# NOTICE OF THE WATERSHED COMMITTEE MEETING/SPECIAL MEETING OF THE BOARD OF DIRECTORS

Thursday, March 20, 2025 at 9:30 AM

- b. Azalea Hill Trail Restoration Revisions

# Marin Municipal Water District Addendum to the Amendment of the Mt. Tamalpais Watershed Road and Trail Management Plan – Restoration of Azalea Hill Initial Study/Mitigated Negative Declaration

Figure 1 Azalea Hill Restoration Project Location

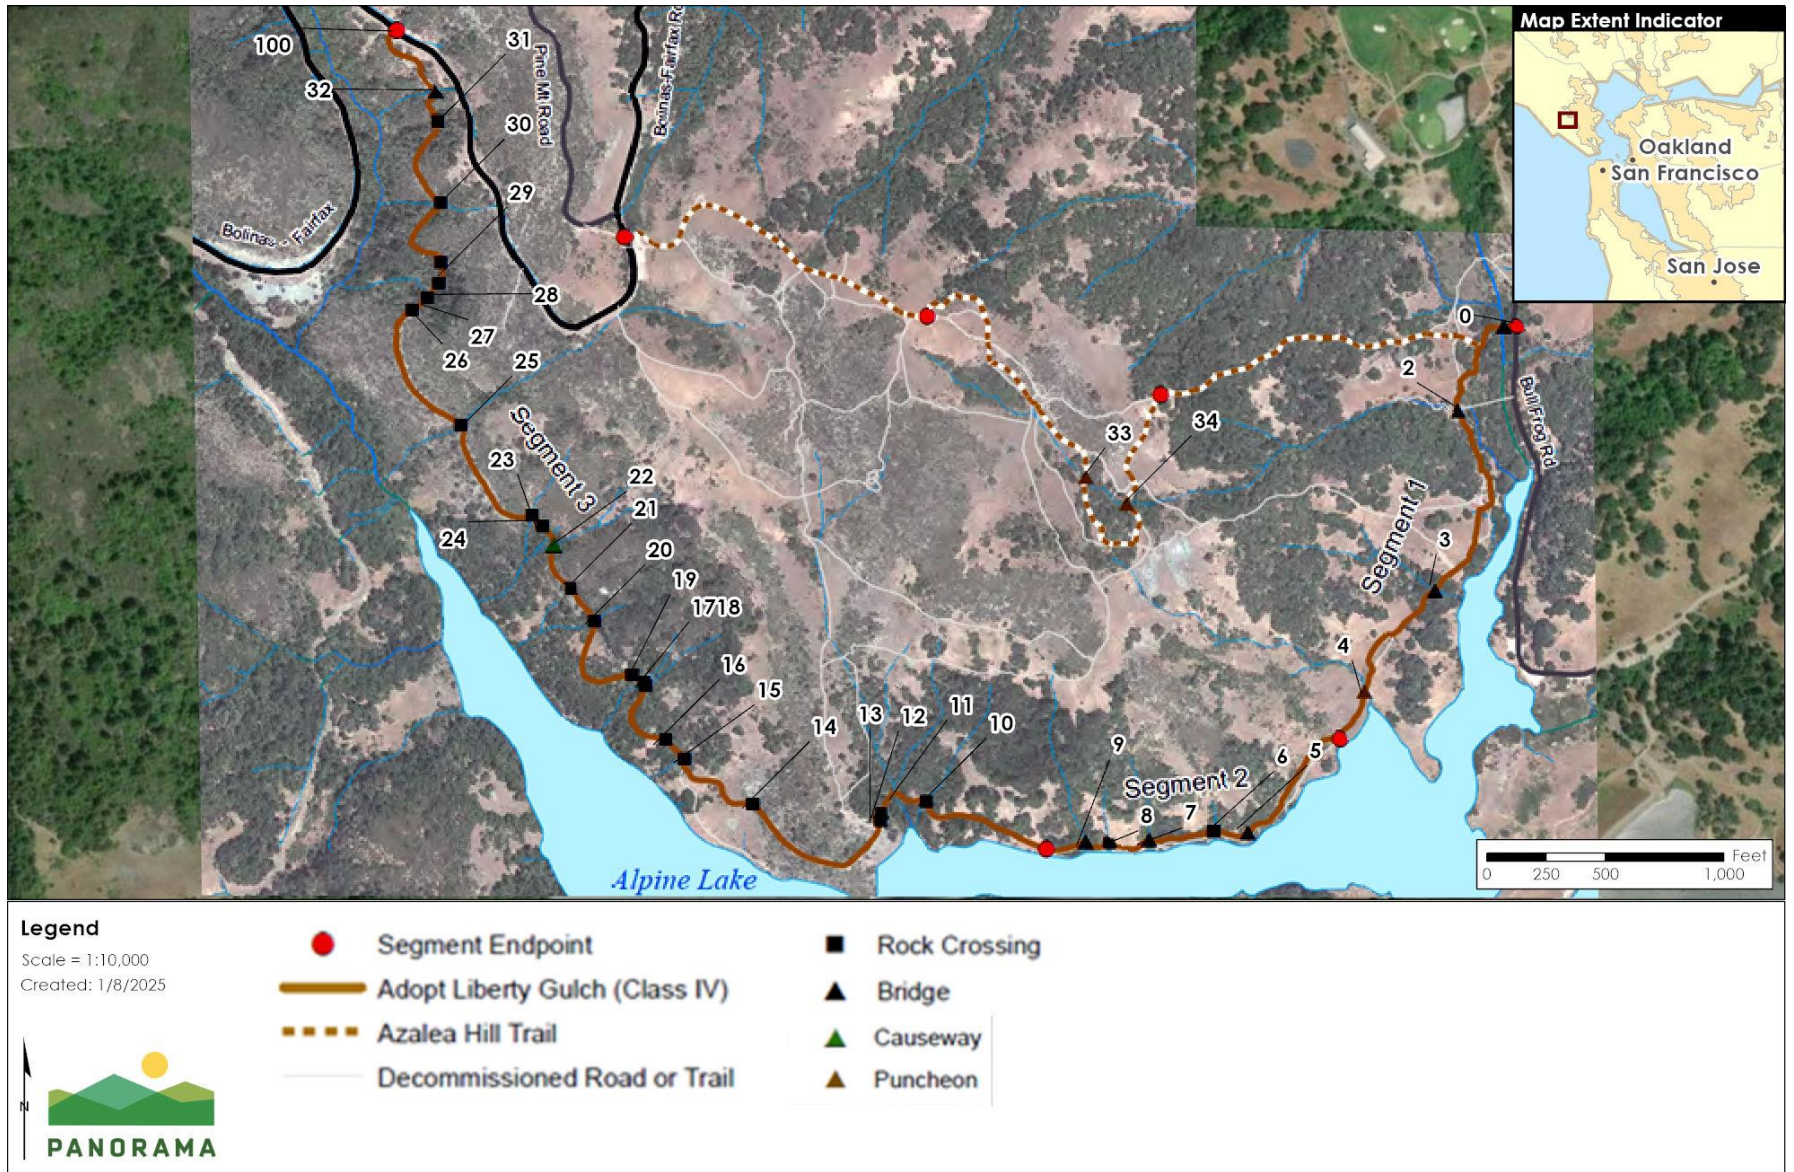
The Project is currently being implemented; however, an approximately 288-foot section of Liberty Gulch Road (within Segment 2, as shown in Figure 1) planned to be improved to a Class IV road through widening from approximately 18 to 24 inches to 4 feet is flanked by extensive populations of rare plants. While the approved Project allows for widening the trail and mitigating the effects to these rare plant populations, the District staff have found that the least impactful method in this area is to leave the trail at its current width and not actively disturb the rare plant populations. Additionally, improvements to Liberty Gulch Road under the Project included stream crossing upgrades at 34 sites. Six of these sites no longer need upgrades or upgrades can be minimized while still protecting water quality and reducing erosion from the road and trail improvements.

A 288-foot section of the Liberty Gulch Road segment, from stream crossing site 7 to 9 (shown in Figure 1), is surrounded by numerous rare plants, including extensive Mt. Tamalpais lessengia and Tiburon buckwheat. This section of trail is narrow (from 18 to 24 inches in width), and sloped, with little room to expand the trail and with rare plants flanking the existing trail. The Azalea Hill Restoration project's IS/MND includes Mitigation Measure 3.2-B.2 that requires avoidance of rare plants, and if avoidance is not practicable, development of a rare plant mitigation and monitoring plan. Per the measure, "The rare plant mitigation and monitoring plan shall maintain pre-project rare plant populations by replacing all affected rare plants via seeding or transplanting (relocating). The success criteria for seeded and relocated plants shall be full replacement at a 1:1 ratio [number of plants established = number of plants impacted] after five years, accounting for annual variability as measured by reference populations near the project area or in similar environmental (soil, aspect, elevation, etc.) conditions."

Page 2.23, Figure 2.05 – Oat Hill Map

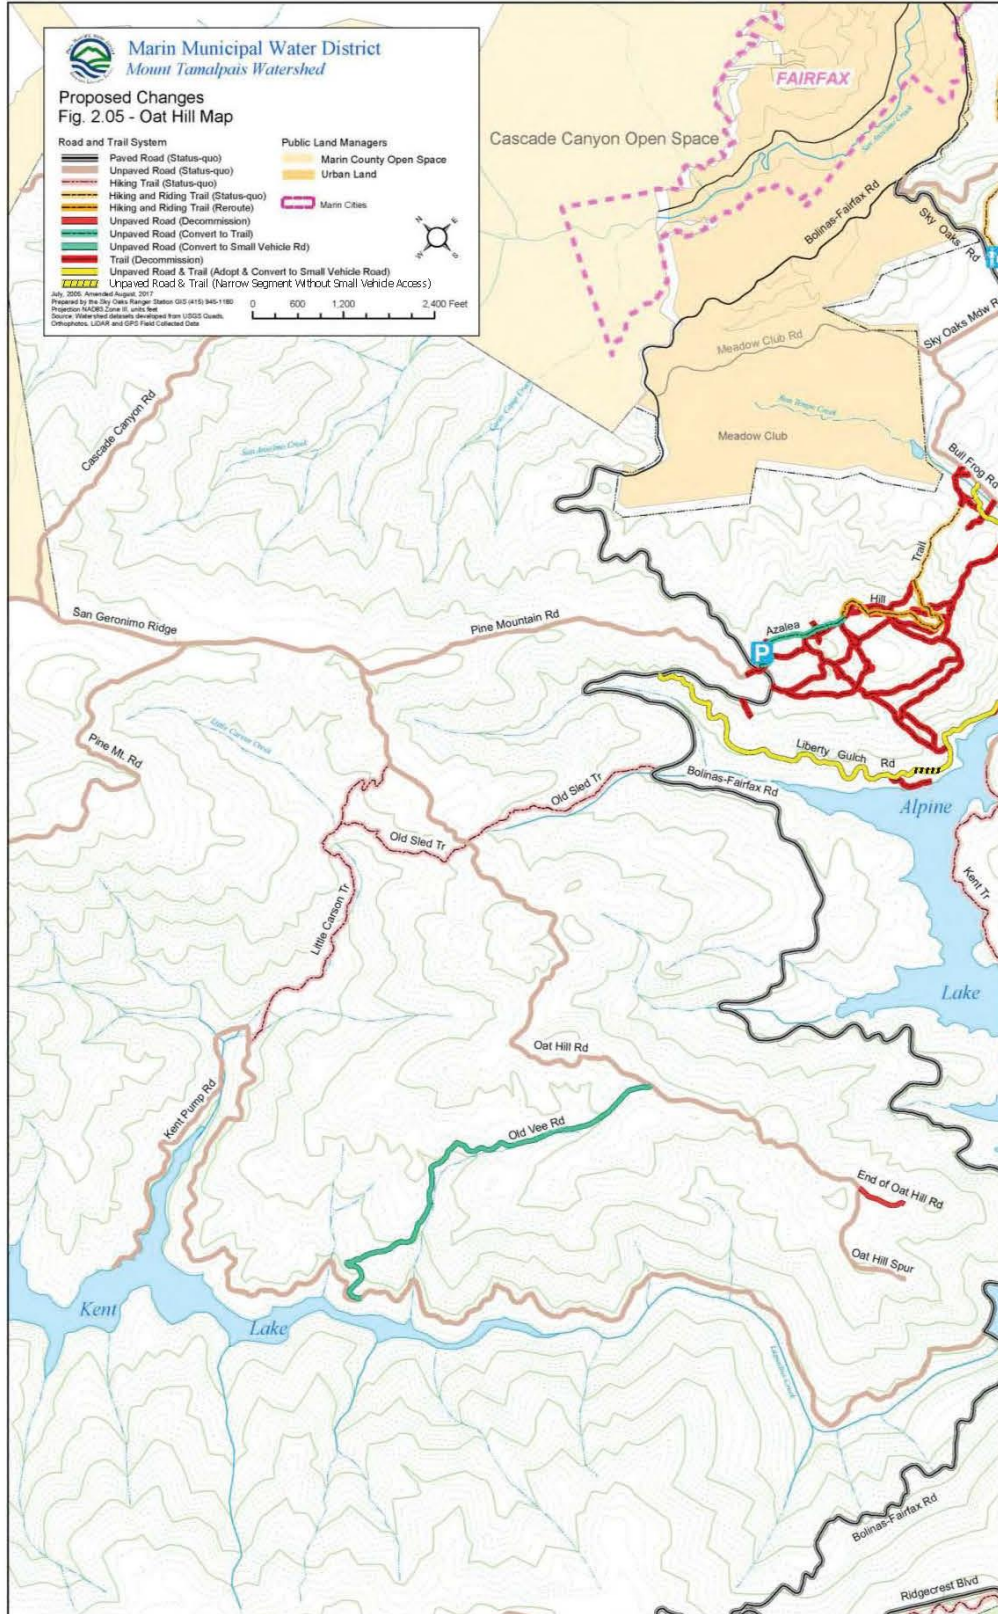
Section 4. Item #b.

Figure 3 Locations of Stream Crossing Improvement Changes for the Revised Project

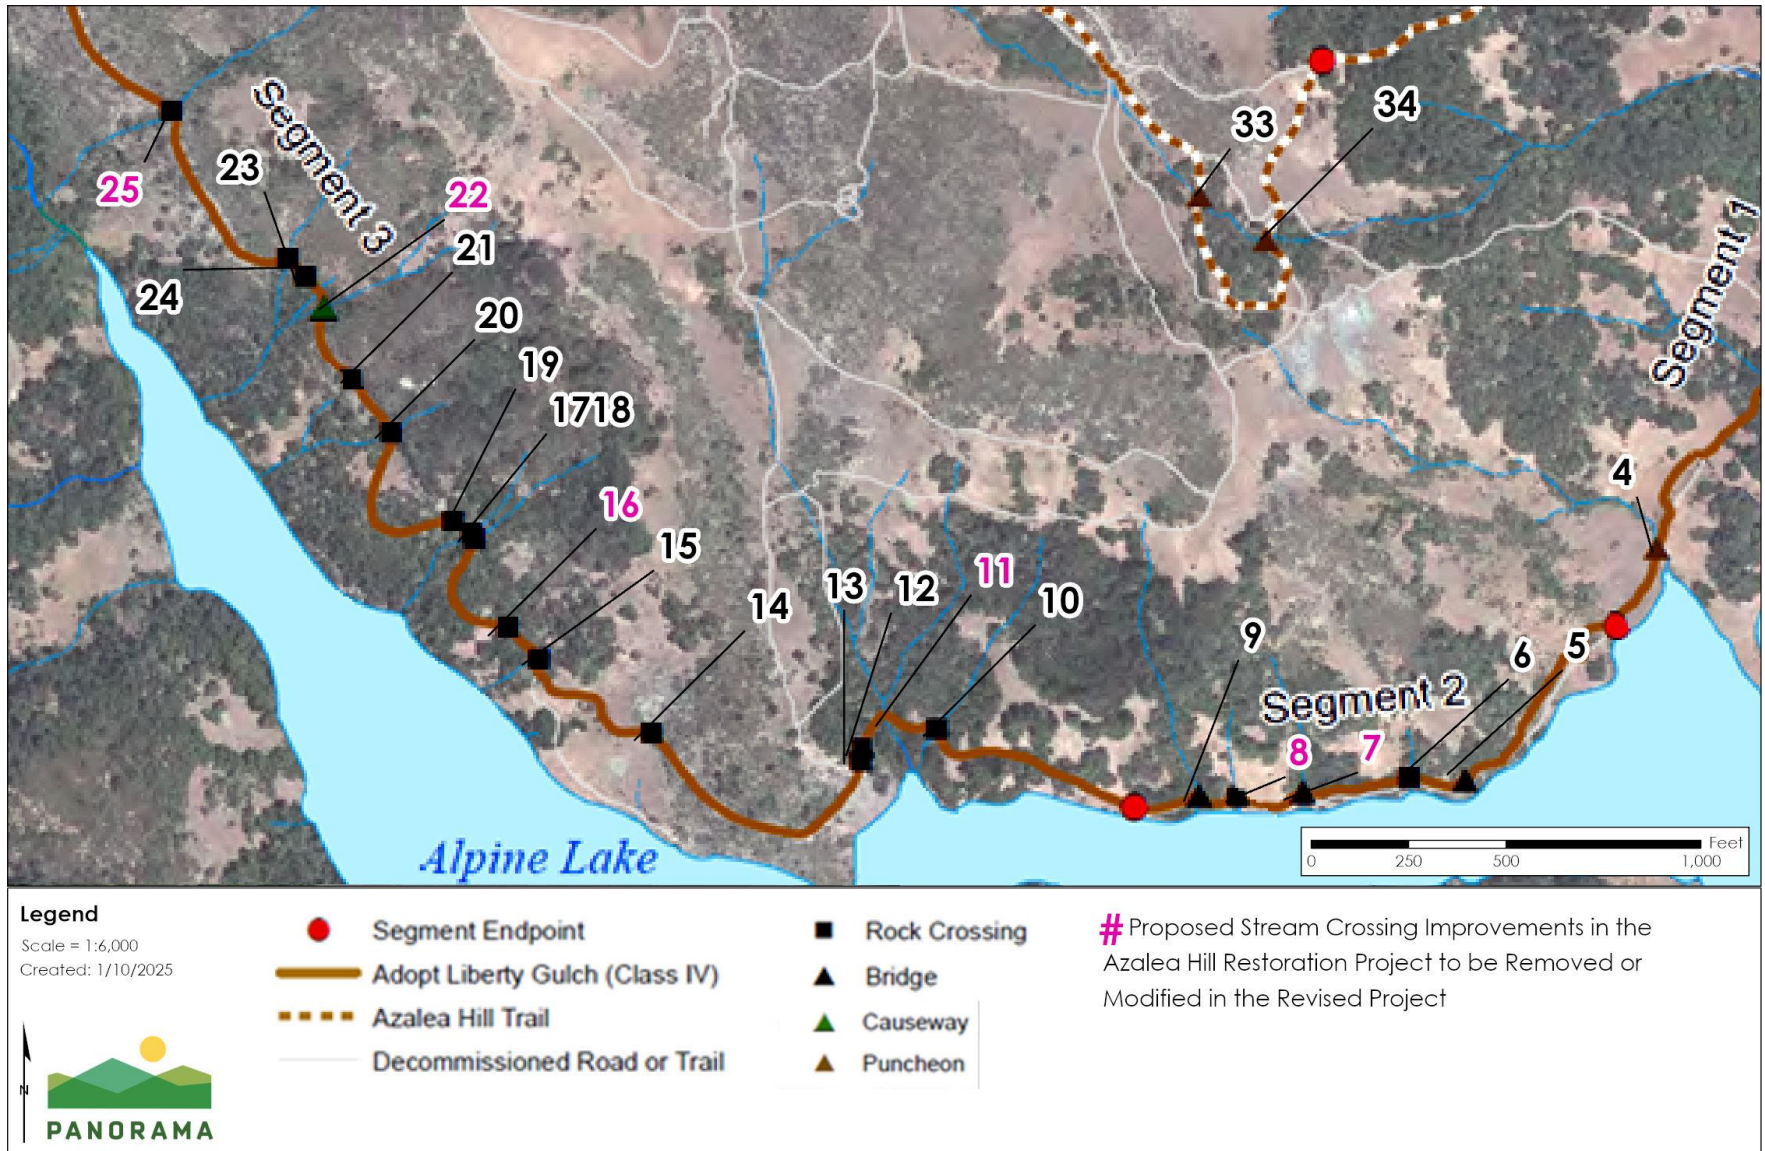
The Azalea Hill Restoration project included 34 stream crossing improvements. Six of these crossing improvements were determined not needed or need less work after field evaluation, which is in line with the District’s stated approach in the Project of being “light on the land” in order to minimize effects to other sensitive resources, including rare plants. The crossings that are removed or modified as part of the revised Project are summarized below and shown in

Figure 3. Each of the modifications or removals were assessed by the District to ensure that the changes would still provide adequate erosion and sedimentation control.

Site	Crossing Type	Initially Proposed Action	Reason for Removal or Modification of Action
7	Bridge	Construct a 20-foot bridge above creek	No bridge construction due to presence of rare plants but some armoring to be installed avoiding the plants and to provide adequate water quality protection. This crossing is within the section of Liberty Gulch Road to be left at current conditions and width.
8	Armor	Construct an armored wet crossing with 6 to 12-inch rock	To retain existing hydrologic function as well as water quality, while avoiding impacts to rare plants precisely hand-place two to three 12" rocks into the stream crossing.
11	Culvert	Slip-line culvert and add trash rack	The culvert is functioning and clean, therefore, no work is needed.
16	Armor	Construct armored wet crossing (5 cubic yards of 1-foot to 2-foot rock), treat approach, pull culvert	The culvert is functioning and clean, therefore, no work is needed.

22	Causeway	Raised boardwalk setback from fill slope edge (50 feet long x 4 feet wide).	No associated road widening is needed in this section of road; therefore, the causeway is not needed to keep users out of the stream. Rolling dips and drainage outlets would be added to adequately protect water quality.
25	Armor	Armored crossing, 50 cubic yards rock over 450 square feet (1-foot to 2-foot ft rock). Pull unstable fill, remove culvert. Treat 400 feet of approach	Leave culvert in place and armor instead of pulling culvert to avoid impacts to rare plants, while maintaining hydrology.
